Access Compliance Report

Public Rights-of-Way

(Curb Ramps)

Intersection ID: 45310	Main Street: BENFIELD_RD	Cross Street: RIDGE_RD	Location: SW
ADA ID: DFE34B9D1A0D	Ramp Type: Perp	Initial Pass/Fail: Fail	Overall Compliance: No
		Severity Score: 25

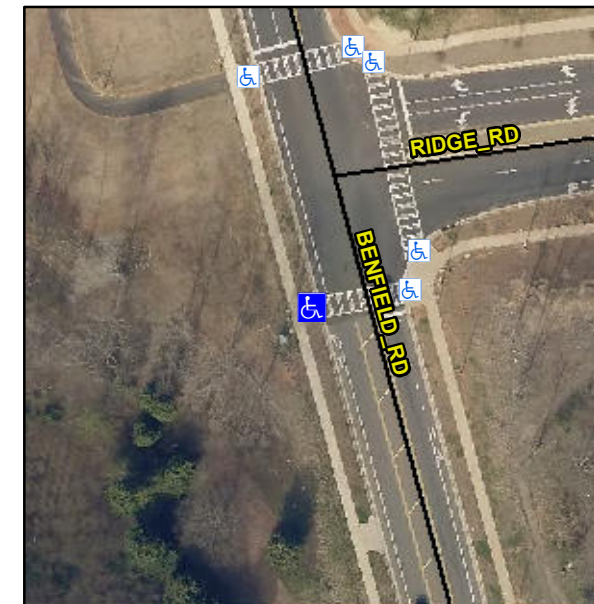
R304.2.2

Compliance	Description	Data	Compliance	Description	Data
N/A	Ramp Length (in)	96.0	No	Ramp Slope (%)	13.1
Yes	Ramp Width (in)	71.5	Yes	Ramp XSlope (%)	2.0
N/A	Flare Type LT	N/A	N/A	Flare Type RT	N/A
N/A	Flare Slope LT (%)	N/A	N/A	Flare Slope RT (%)	N/A
N/A	Flare Traversable LT?	N/A	N/A	Flare Traversable RT?	N/A
N/A	Landing Length (in)	N/A	N/A	DWS Provided?	N/A
N/A	Landing Width (in)	N/A	N/A	DWS Contrast?	N/A
N/A	Landing Slope (%)	N/A	N/A	DWS Length (in)	N/A
N/A	Landing X Slope (%)	N/A	N/A	DWS Full Width?	N/A
N/A	Landing Curb? (Y/N)	N/A	N/A	DWS Offset (in)	N/A
N/A	Shared Landing?	N/A			
N/A	Gutter Ponding?	N/A	N/A	Gutter Slope (%)	N/A
N/A	Gutter Lip Ht (in)	N/A	N/A	Gutter X Slope (%)	N/A
N/A	Painted X Walk1?	Yes	N/A	Painted X Walk2?	N/A
	X Walk 1 Direction	To E		X Walk 2 Direction	N/A
N/A	X Walk 1 Width (in)	120.0	N/A	X Walk 2 Width (in)	N/A
	X Walk 1 Slope (%)	2.4		X Walk 2 Slope (%)	N/A
	X Walk 1 X Slope (%)	1.8		X Walk 2 X Slope (%)	N/A

Remove & Replace Entire Ramp.
